Access Compliance Report

Public Rights-of-Way

(Curb Ramps)

Intersection ID: 31771	Main Street: STARNES RANDALL RD	Cross Street: PINYON PINE LN	Location: SW
ADA ID: 0254353219CE	Ramp Type: PerpDiag	Initial Pass/Fail: Fail	Overall Compliance: No
Severity Score: 25			
Codes/Mitigation Info/Possible Solution		Field Measurements/Component Compliance

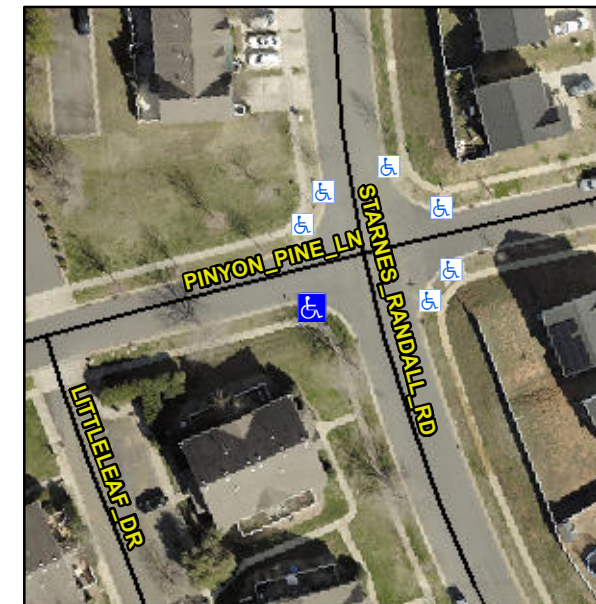
Not Found, R304.2.2, R304.5.3

Compliance	Description	Data	Compliance	Description	Data
N/A	Ramp Length (in)	83.0	No	Ramp Slope (%)	10.2
Yes	Ramp Width (in)	48.0	No	Ramp XSlope (%)	6.1
N/A	Flare Type LT	N/A	N/A	Flare Type RT	N/A
N/A	Flare Slope LT (%)	N/A	N/A	Flare Slope RT (%)	N/A
N/A	Flare Traversable LT?	N/A	N/A	Flare Traversable RT?	N/A
N/A	Landing Length (in)	N/A	N/A	DWS Provided?	N/A
N/A	Landing Width (in)	N/A	N/A	DWS Contrast?	N/A
N/A	Landing Slope (%)	N/A	N/A	DWS Length (in)	N/A
N/A	Landing X Slope (%)	N/A	N/A	DWS Full Width?	N/A
N/A	Landing Curb? (Y/N)	N/A	N/A	DWS Offset (in)	N/A
N/A	Shared Landing?	N/A			
N/A	Gutter Ponding?	N/A	N/A	Gutter Slope (%)	N/A
N/A	Gutter Lip Ht (in)	1.0	N/A	Gutter X Slope (%)	N/A
N/A	Painted X Walk1?	No	N/A	Painted X Walk2?	No
	X Walk 1 Direction	To E		X Walk 2 Direction	To N
N/A	X Walk 1 Width (in)	N/A	N/A	X Walk 2 Width (in)	N/A
	X Walk 1 Slope (%)	1.9		X Walk 2 Slope (%)	0.6
	X Walk 1 X Slope (%)	3.2		X Walk 2 X Slope (%)	3.1

Remove & Replace Curb Ramp With Two New Directional Ramps or Equivalent.
